CITY OF CONWAY, ARKANSAS HISTORIC DISTRICT COMMISSION

1820 Duncan Street - Exterior Modifications

1154 Donaghey Avenue - Exterior Modifications

Site Plan provided by Applicant

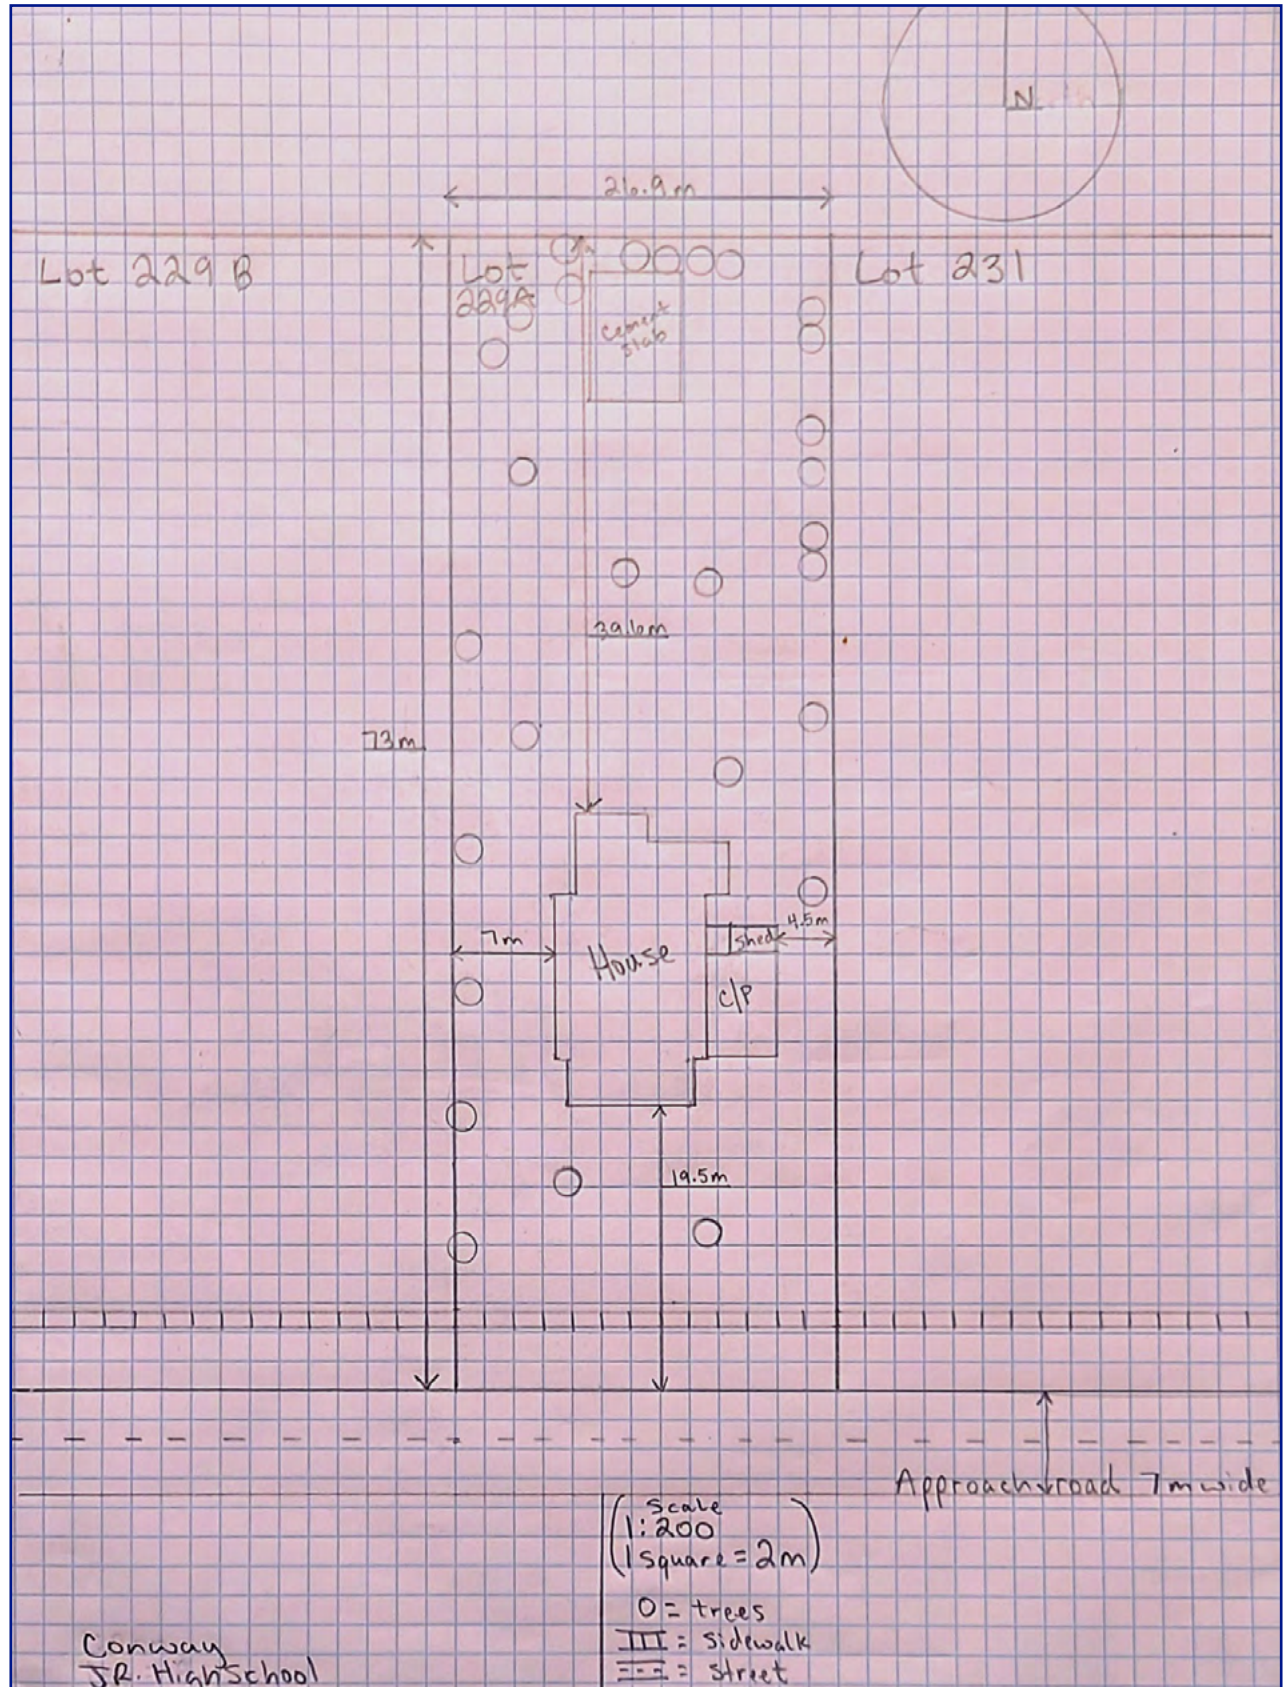
The proposed addition to the rear appears appropriate and will not detract from the structure. However, the addition will require being placed on a proper foundation.

1. All previous window openings be reopened and filled with windows to match the existing size of openings.
2. All windows will be required to be one-over-one.
3. The porch and step railings shall match in materials, and match the paint of the existing wood column tops.
4. If siding for the structure is replaced, it must be replaced with wood or similar material such as Hardie® siding/LP SmartSide®. The siding must have a maximum of a 4" exposure to more closely match the existing narrow exposure.
5. All fascia and soffits shall be repaired with wood or a wood-like material such as Hardie® siding/LP SmartSide®.
6. Roofing shall be composed of shingles.
7. No shutters shall be allowed.
8. HVAC equipment be placed in manner to prevent view from the street or screened by landscaping/fencing.
9. The rear addition shall be placed on a foundation that meets building code requirements.

South Elevation provided by Applicant

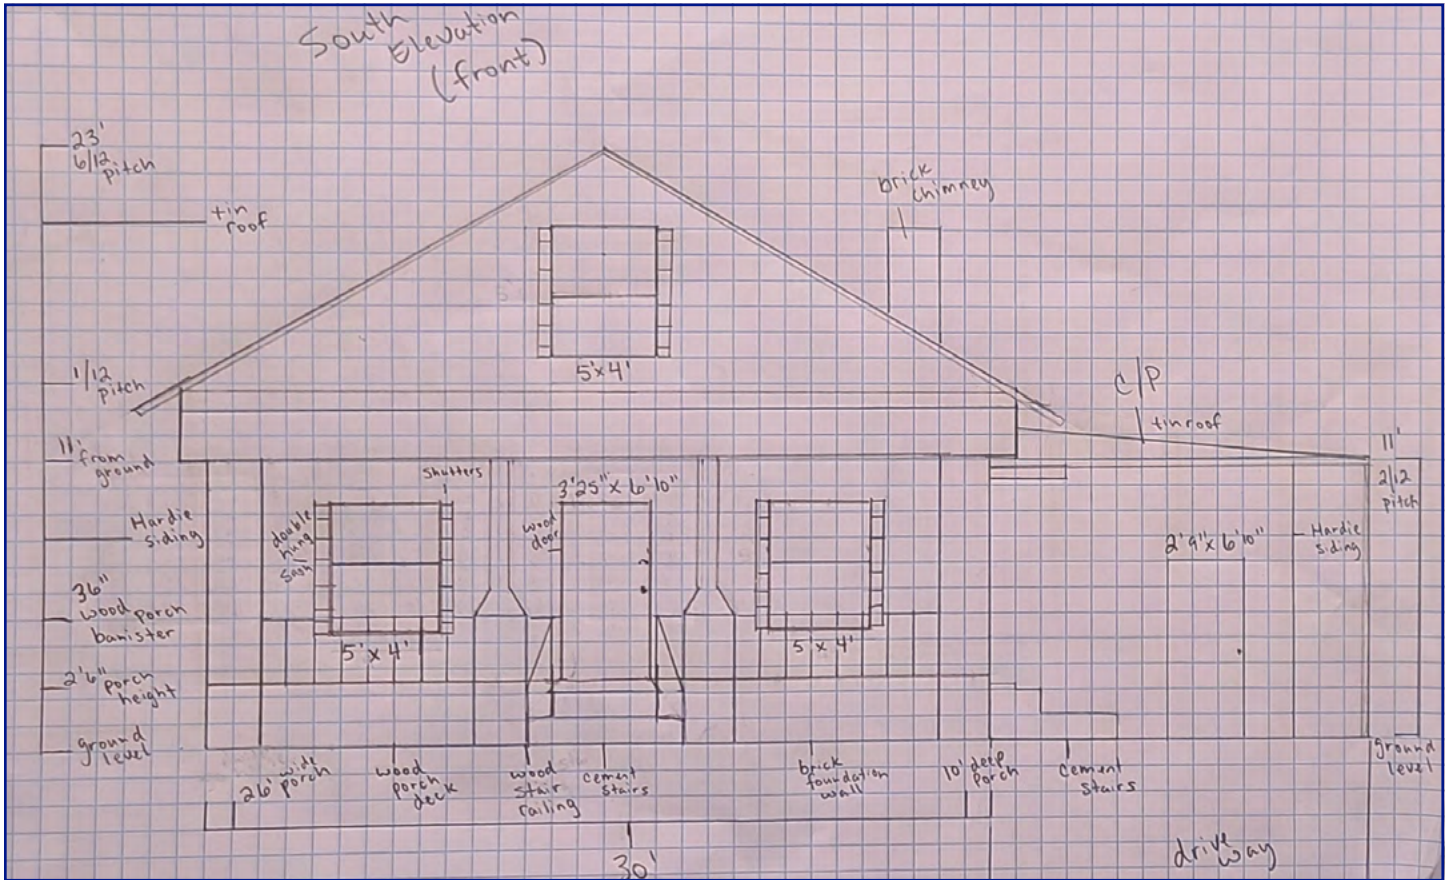
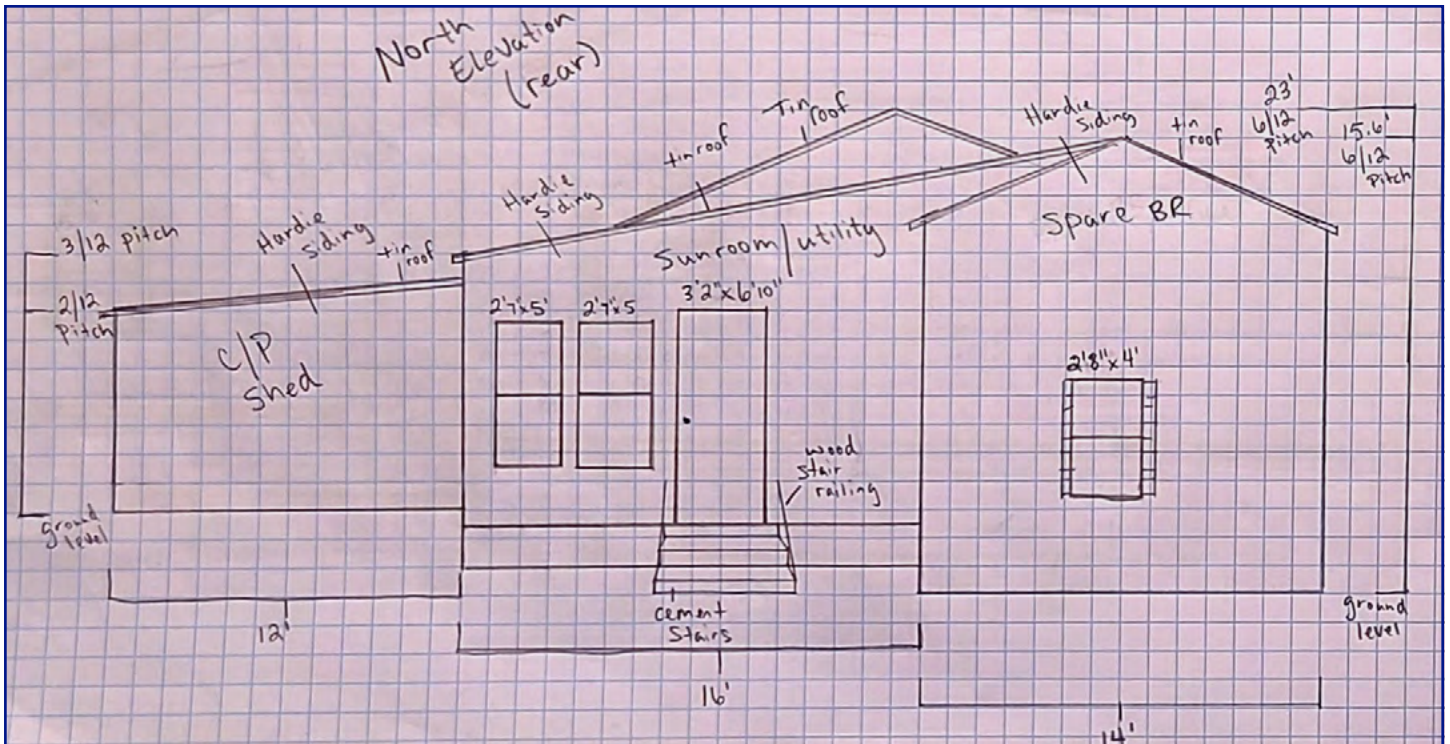
The applicant has removed all windows from the structure and filled in numerous window openings. This will take the structure out of compliance with standards. Recommend requiring that all previous window openings be reopened with one-over-one windows matching the original sizes.

The applicant is proposing to replace the existing narrow exposure (2.5"-3") wood siding with Hardie® siding or similar material. Recommend requiring the existing wood to be retained or if replaced, replaced with Hardie® siding/LP SmartSide® product with an exposure of no more than 4". Furthermore, existing gable brackets have been removed. Recommend requiring they be replaced in kind.

The structure has an existing ribbed metal roof that is in a state of disrepair. This is not an approved roofing material and not compatible to the surrounding area. Recommend requiring replacement with a shingle roof. The applicant is additionally proposing shutters for the structure. This is not appropriate and recommend not allowing this addition.

Site Plan provided by Applicant

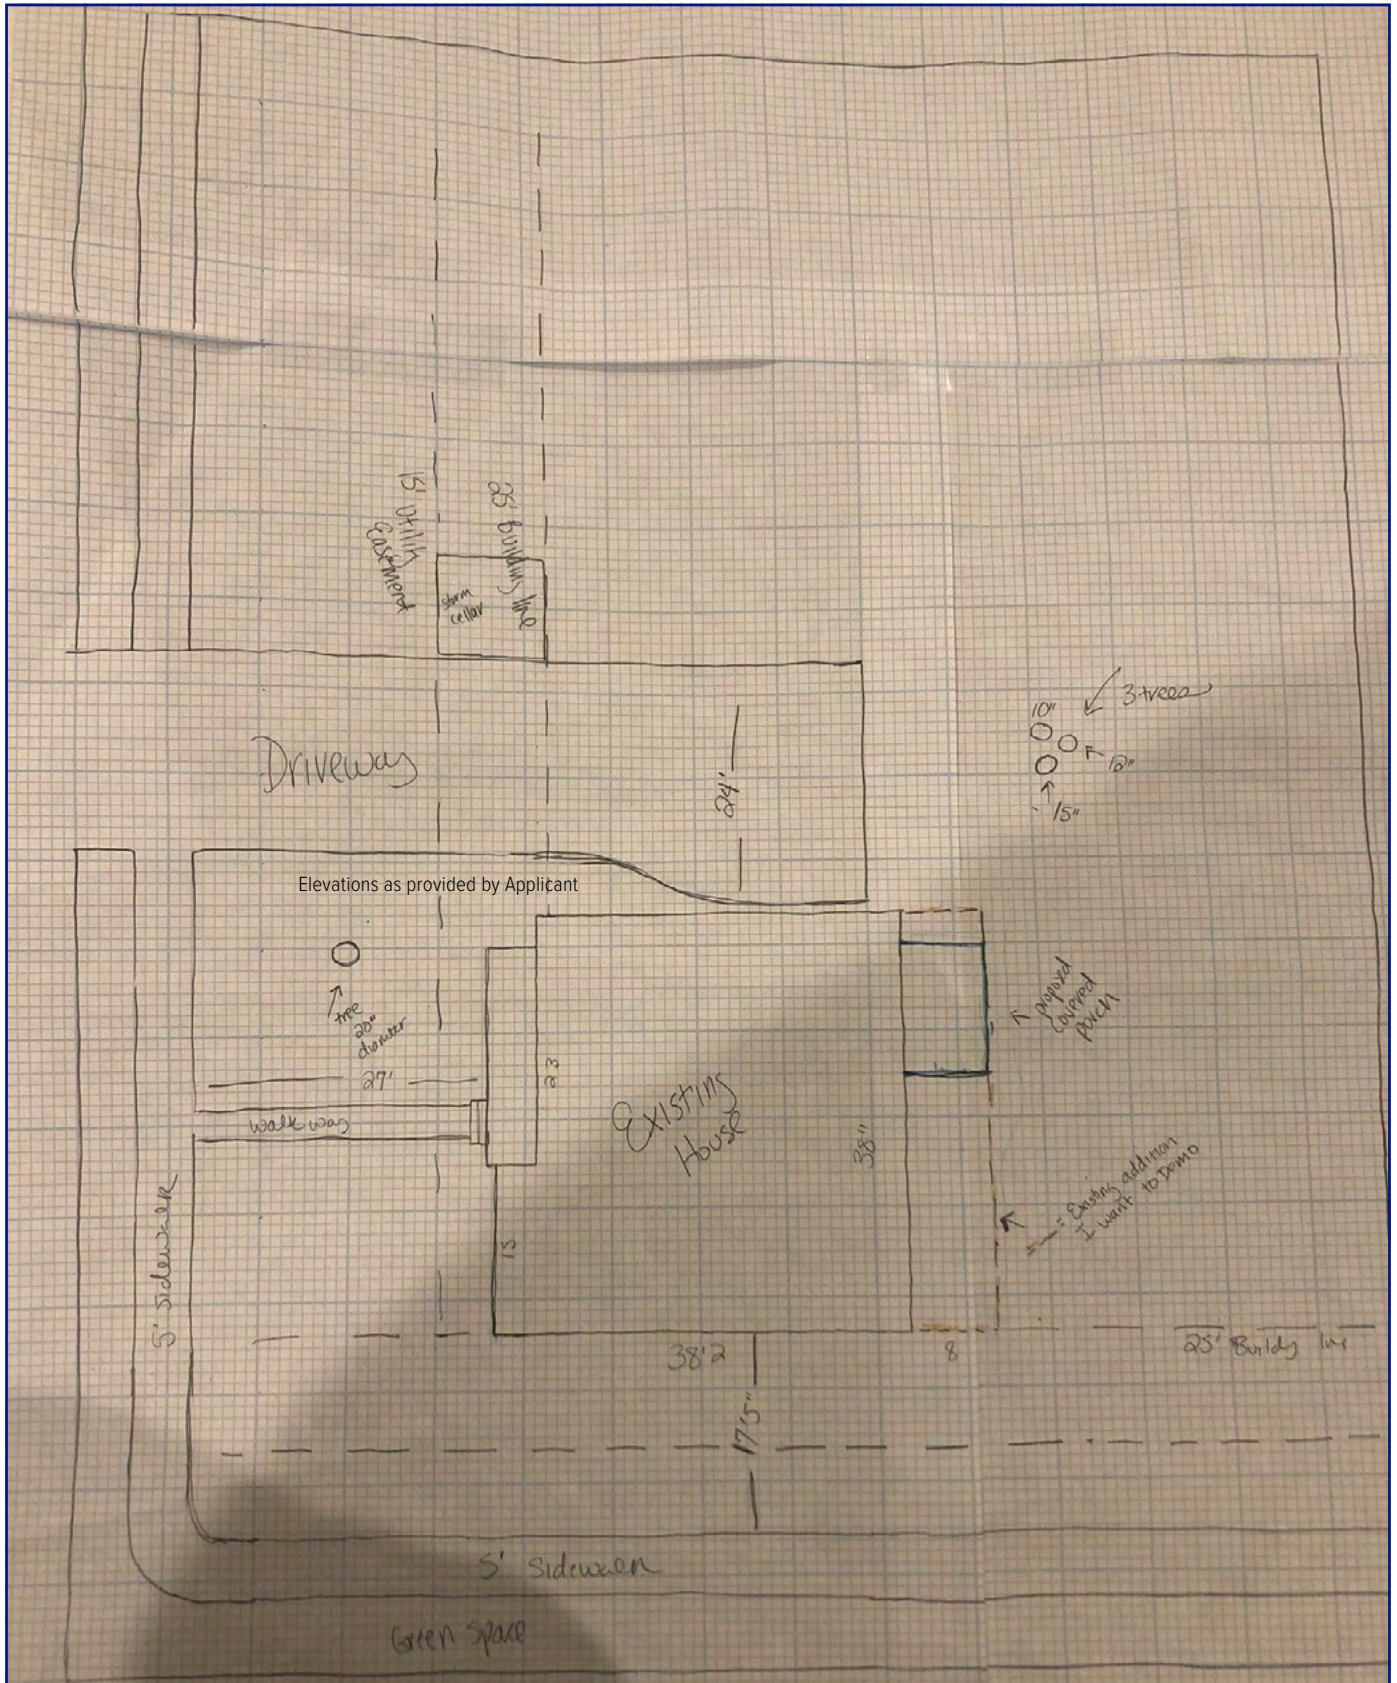
The proposed use of a metal roof on the porch with wood fascia to mimic the arched form common to mixed masonry homes is not compatible. Recommend requiring the porch roofing match the home with wood porch columns at least 8" in diameter and allow arched supports similar to the image. Applicant initially proposed a covered porch addition at the rear, but due to setback requirements has removed this from the scope of work. If applicant wishes to add the porch in the future additional Staff and/or HDC review will be required. The change accounts for discrepancies in the site plan and elevations.

1. Windows be replaced with one-over-one style windows. The large front window may have a single pane window.
2. Require 8" wood columns for the front porch with an allowance for arched wooden supports.
3. Require roofing material for the front porch match that of the structure as architectural shingles.
4. HVAC equipment be placed in manner to prevent view from the street or screened by landscaping/fencing.
5. The damaged tree by the front porch may be removed with a canopy tree planted to replace it.
6. The masonry components of the structure may not be painted.
7. All fascia and soffits shall be repaired with wood or a wood-like material such as Hardie® siding/LP SmartSide®

Elevation sketches provided by Applicant

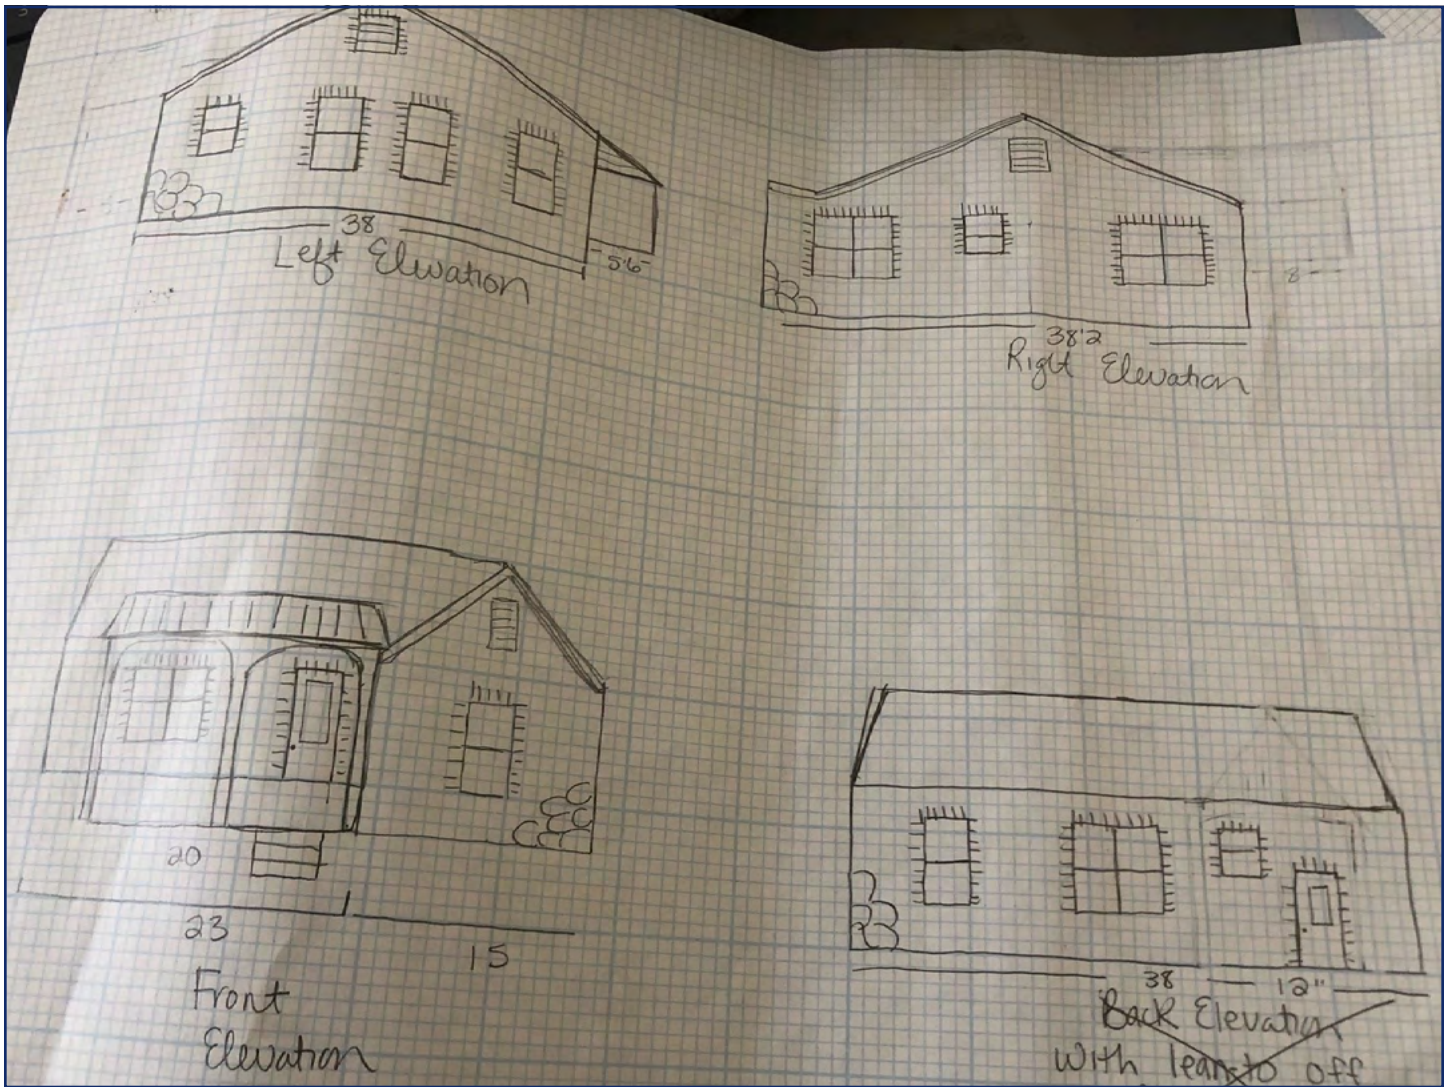
Based on the existing condition of the structure replacement of the windows is warranted. Applicant has proposed compatible one-over-one windows. The original large front window was a divided light window similar to the six-over-six windows throughout the home.
